SIL 22-EP-17
November, 2017
Page 1 of 2

SUBJECT: Release of Allison Transmission 5th Generation Controls

MODELS AFFECTED: H 40/50 EP™ System

Figure 1. Current System vs. 2018 System

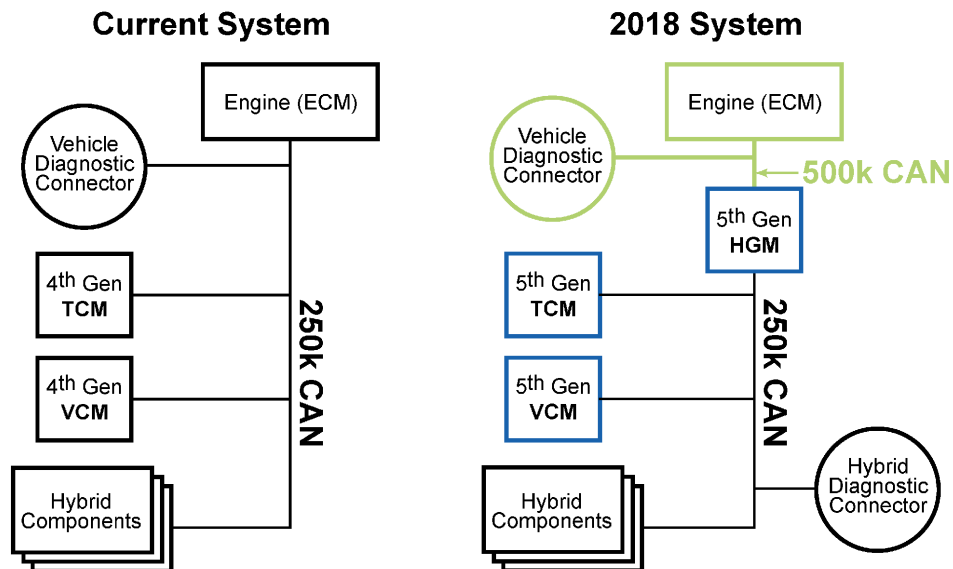
Effective with model year 2018, Allison Transmission will release 5th Generation Controls and software for the H 40/50 EP™ product line. The primary change involves a new controller configuration used to support 500k baud CAN communication in vehicles. Three (3) 5th Generation A64 controllers will be used:

- Hybrid Gateway Module (HGM)
- Transmission Control Module (TCM)
- Vehicle Control Module (VCM)

The new HGM will bridge the 500k baud vehicle CAN and the 250k baud H 40/50 EP™ CAN (refer to [Figure 1](#)).

The A64 TCM (P/N 29556885) will be used for the TCM, VCM, and the new HGM controller. The new 5th Generation controllers are not backwards compatible in vehicles with 4th Generation Control configurations.
